**Aeronautical Study No.
2004-AAL-104-OE**

**** PUBLIC NOTICE ****

Structure: Fire Island Wind Turbine Project
Location: Anchorage, AK
Latitude: 61-09-32.51N NAD 83
Longitude: 150-13-36.00W
Heights: 351 feet above ground level (AGL), 600 feet above mean sea level (AMSL)

NARRATIVE AERONAUTICAL STUDY NO. 2004-AAL-104-OE

Orange triangles are proposed wind turbine locations

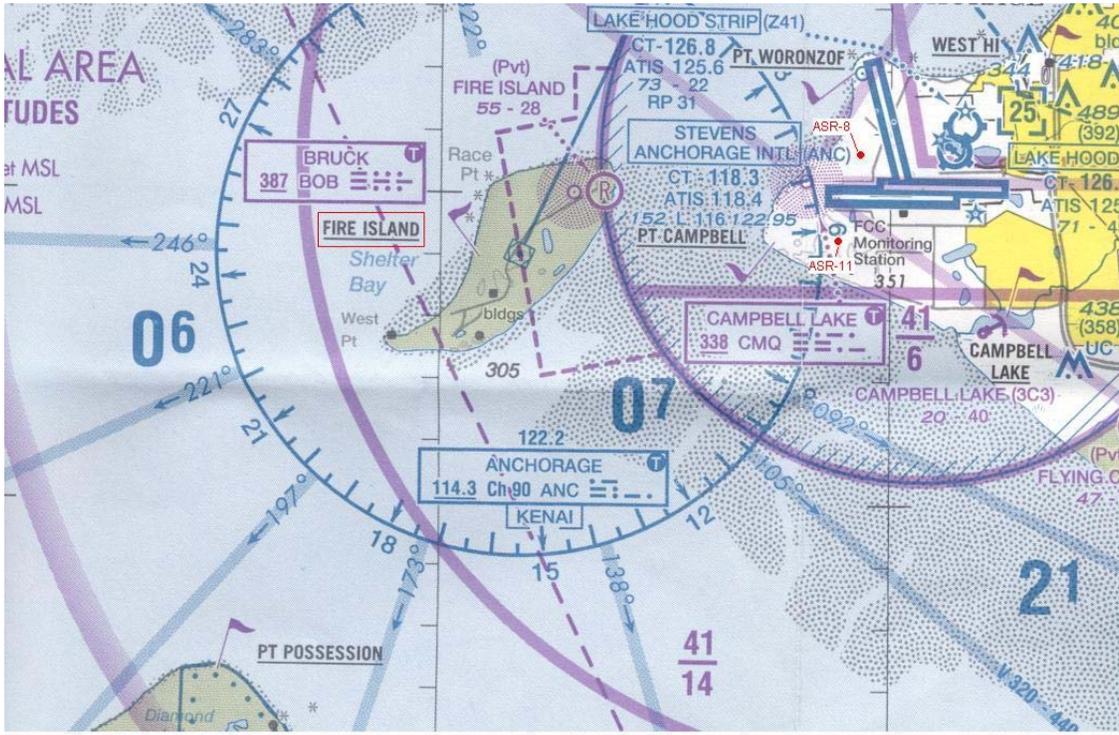
The proposed wind turbine locations are within what is considered to be a critical operations area, an area extending from the runway out to a 10 mile final including five (5) miles either side of the final approach course. This 50 square mile area is where the last opportunity for approach sequencing and spacing for arriving aircraft to the final approach course occurs. The potential radar clutter interference in this area is a major concern to Air Traffic personnel as it directly impacts the efficiency and capacity at Anchorage Ted Stevens International Airport.

Primary radar is the chief means of separating aircraft, while secondary radar provides the ability of computer-assisted tracking. The possible loss of primary radar returns in these maneuvering areas would limit the controller's ability to provide merging target procedures for aircraft on approach relative to any aircraft that might be flying on the Fire Island route. The Anchorage Airport Traffic Control management is opposed to any degradation of their primary radar capabilities.
